Document n°	FRN-SB2008-01-programmer 816290735
Brand	Smeg
Models involved	90cm ovens, double ovens
Cause	Component update
Description of modification	Introduction of a new programmer, with a different number of connections compared to the previous component: The old programmer had <b>5 connections</b> whereas the new one has <b>6</b> . Therefore in order to be able to make the electrical connection correctly, an accessory wiring is needed for the new 6-pole programmer.
Date of introduction	starting from <b>25/01/2008</b> → introduction of modified wiring
Interchangeability	<b>YES, NOTE: <u>the programmer part number remains unchanged (partno.816290735) therefore follow the instructions in this document in order to connect the component correctly.</u></b>

**Photo1- DETAIL OF PROGRAMMER WITH 5 CONNECTIONS**

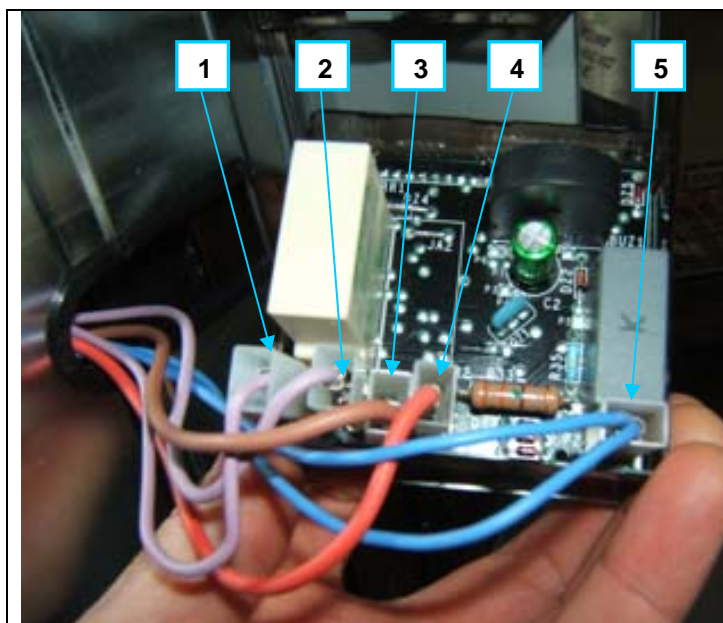
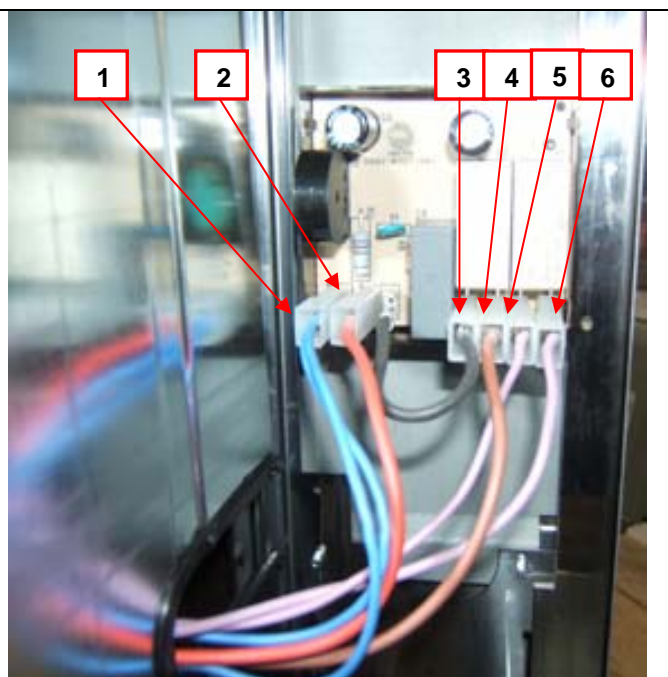
- If the programmer received as a spare part has **5 connections** → connect it without the accessory wire because the wiring on the oven has the old configuration (photo 1)
- If the programmer received as a spare part has **6 connections**→ connect it with the accessory wire (photo 2)

→ IF THE APPLIANCE WAS PRODUCED BEFORE **24/01/2008** ORDER PROGRAMMER PARTNO **816290735** + ACCESSORY WIRING PARTNO **821290576**.

**Photo 1- DETAIL OF PROGRAMMER WITH 5 CONNECTIONS WITH ACCESSORY WIRE DISCONNECTED**

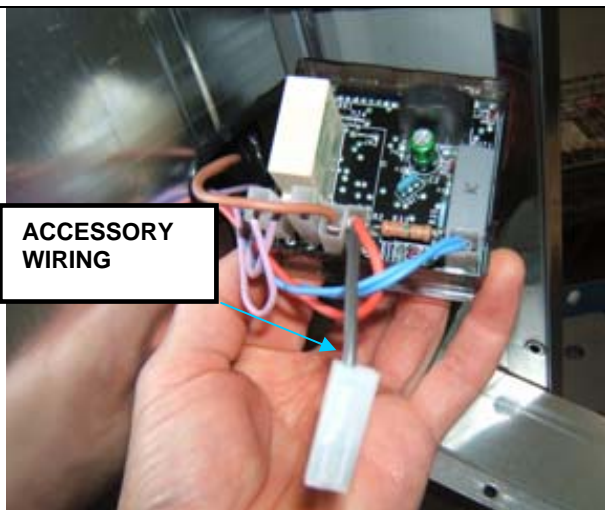
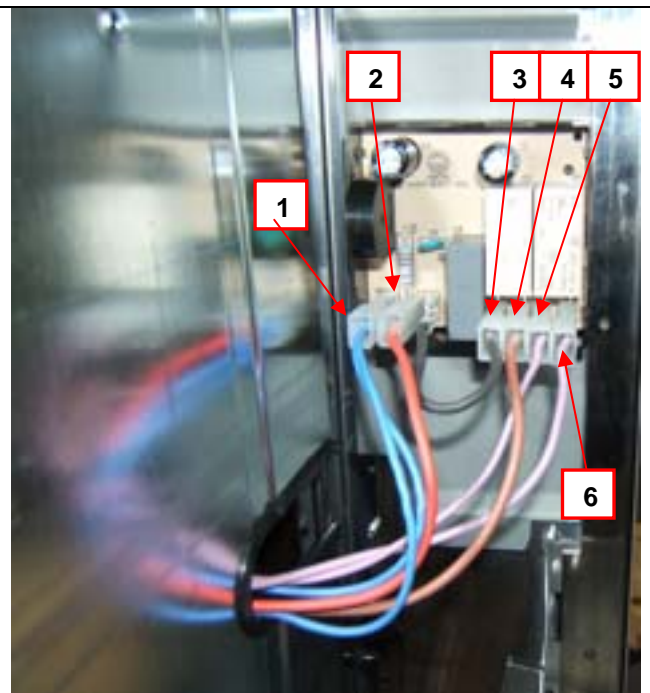
- If the programmer received as a spare part has **5 connections** → **do not** connect the accessory wire (photo 1)
- If the programmer received as a spare part has **6 connections** → connect it to the accessory wiring which is already present on the appliance (photo 2) collegarlo con il cablaggio accessorio già presente sull'apparecchio (foto 2)

→ IF THE APPLIANCE WAS PRODUCED **FROM 25/01/2008 ONWARDS** ORDER **ONLY** THE PROGRAMMER PARTNO **816290735**  
(THE APPLIANCE HAS THE MODIFIED WIRING ALREADY)
